VNI West Project Assessment Conclusions Report Volume 2: Additional Consultation Report Submissions

May 2023

Regulatory Investment Test for
Transmission

Figure 10 Gippsland REZ transmission – available and post Latrobe Valley (LV) coal closure (Step Change) - Additional Consultation Report market modelling outcomes

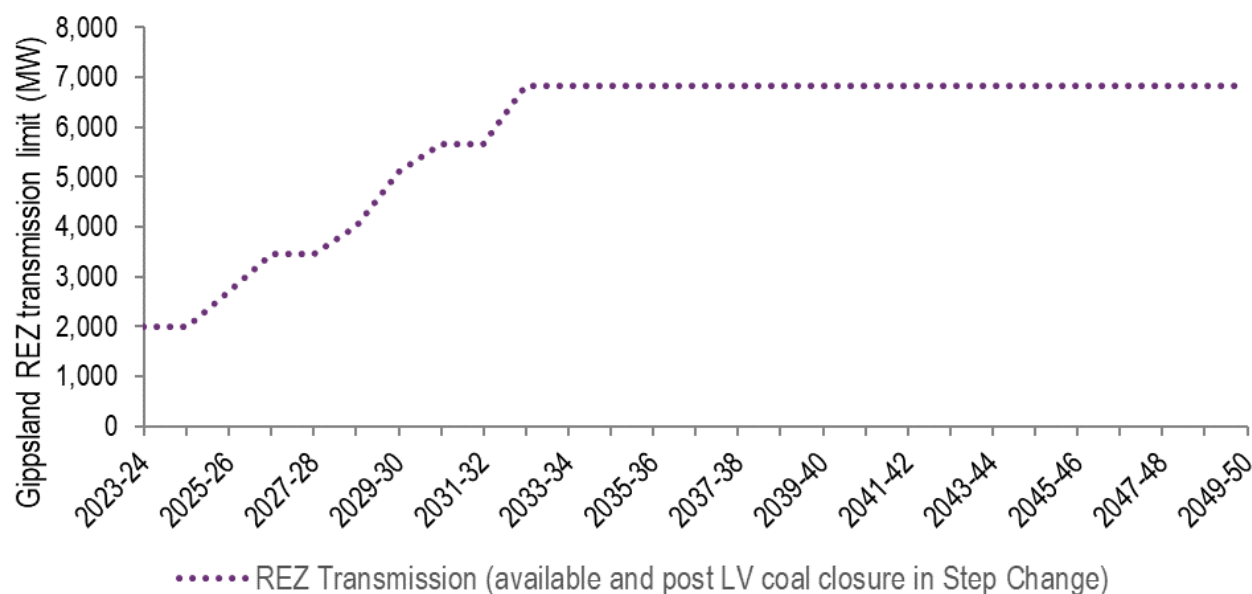
Transmission constraints applied to represent the transmission network limitations out of the Gippsland REZ account for an increase in transmission capacity with closure of Latrobe Valley coal-fired generation. The spare network capacity for the Gippsland REZ today is estimated to be approximately 2,000 MW, and this progressively increases over time as coal-fired generation in Latrobe Valley closes. Once all coal-fired generation has closed in Victoria (assumed to be from 2032 in the *Step Change* scenario based on ISP market modelling), the spare network capacity assumed in the Additional Consultation Report modelling has increased to around 6,800 MW at no cost, as shown in Figure 10. This is obviously contrary to p.10 of the submission, which claimed a blanket 2,000 MW transmission limit was applied.

Further increases in capacity beyond those shown in Figure 10 would require transmission augmentation. This is allowed in the modelling at an additional cost, measured in \$m/MW, which has been derived and consulted on as part of the ISP process through assessment of the likely cost and transmission capacity increase from potential line augmentations to locations where there is generator connection interest. The value of the REZ expansion cost applied to the Gippsland REZ is the lowest of the expansion costs applied to any REZ in Victoria, and lower than many other REZs in the NEM. The expansion cost reflects the current cost of building additional transmission capacity and is essentially the equivalent of the 'low cost' additional capacity cost in the submission. The submission claimed this is a steep penalty being applied beyond 2,000 MW. In fact, the cost applied beyond the 2,000 MW is the cost of expanding transmission capacity from the Gippsland REZ, and not a steep penalty as claimed.

Figure 11 Solar and onshore wind build in Gippsland REZ, Step Change – Additional Consultation Report market modelling

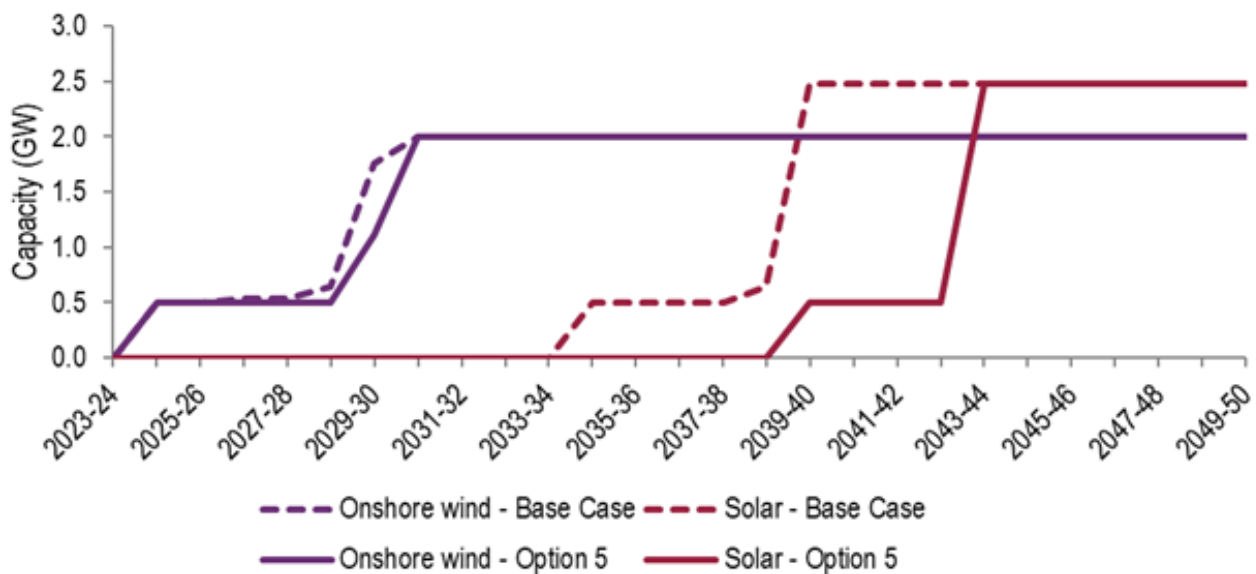
RIT-T modelling outcomes of the Additional Consultation Report market modelling for the forecast build in Gippsland REZ are shown in Figure 11, and show that Gippsland REZ is developed to its fullest within the modelling period; that is, to its assumed resource limits.

The modelling shows that this is the least-cost way to develop renewable generation in Victoria – progressively building renewable generation in a number of REZs simultaneously to maximise the benefits of diversity and match supply with demand growth. As VNI West opens up access to higher quality renewable generation in the Western Victoria and Murray River REZs, renewable development in Victoria is forecast to be distributed across more REZs, and some of the REZs with poorer quality renewable resources are filled more slowly³⁶. Of course, this is not to say that developers will time or size their investment to exactly match the RIT-T modelling. In reality, investment decisions are made taking into account a large number of factors, and the open access regime allows them to connect at any time, provided the connection does not impact power system security.

Figure 13 Spill in Murray River and Western Victoria REZs, Step Change scenario, Option 5, Additional Consultation Report

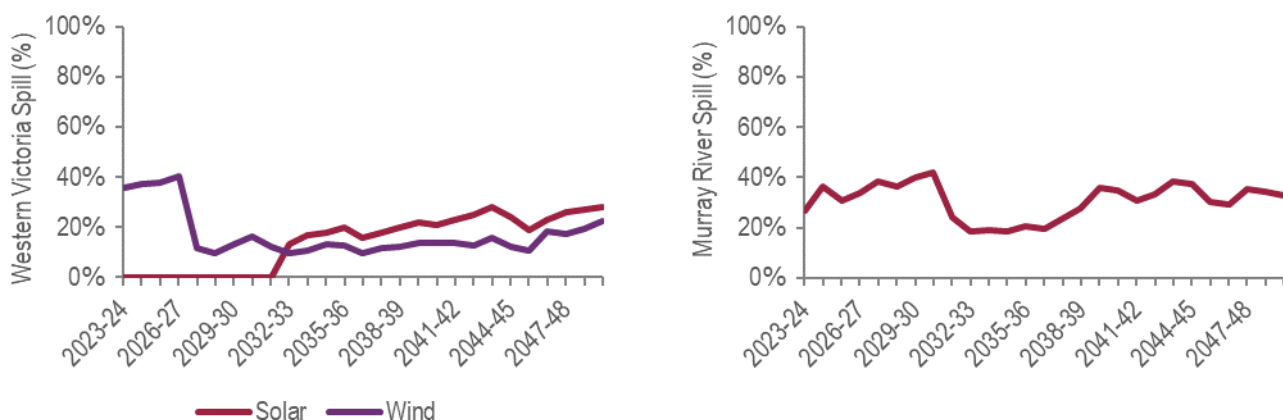
The analysis of VNI West forecasts that renewable spill in Western Victoria and Murray River REZs (from Additional Consultation Report market modelling outcomes) significantly decreases after WRL commissioning in 2027 and VNI West commissioning in 2031 (see charts below), although – similar to the NEM-wide trend – the spill is forecast to increase in the 2040s, mainly due to the low carbon emissions volume allowed in that decade. The majority of spill increase in the NEM is forecast to be during the solar operating hours. The combined generation output from the significant growth in distributed PV and build of large-scale solar exceeds assumed NEM system load at times (after consideration of dispatchable pumped/charging load), resulting in some available energy simply not being consumed. While natural to assume that this spill should be soaked up by storage, or flexible loads, there comes a point where, based on CSIRO GenCost 2021-22³⁹ projections of future capital costs for generation and storage, the incremental value of soaking up the solar does not justify the investment in any more storage. The large-scale solar investment is still a key part of the portfolio of investment in renewable generation, storage and consumer energy resources (such as rooftop PV) required to transition to net zero at least cost, despite this spill.

It is noted that the spill amounts shown in Figure 13 and Figure 14 are much lower than the values quoted in the submission. AVP and Transgrid sought clarification from the submitters on how they calculated the spill, and can confirm that the formula they used was correct, but we have not been successful in replicating their energy spill numbers – in particular, the PV spill of 50% in Western Victoria (V2) REZ that is quoted in Table 6 and several other places. The forecast spill presented in EY's market modelling report is calculated hour-by-hour directly from the simulations and represents the amount of available energy that was not able to be consumed in that hour due to either economic reasons or transmission congestion. AVP and Transgrid therefore have confidence in the reported spill outcomes of the EY assessment.
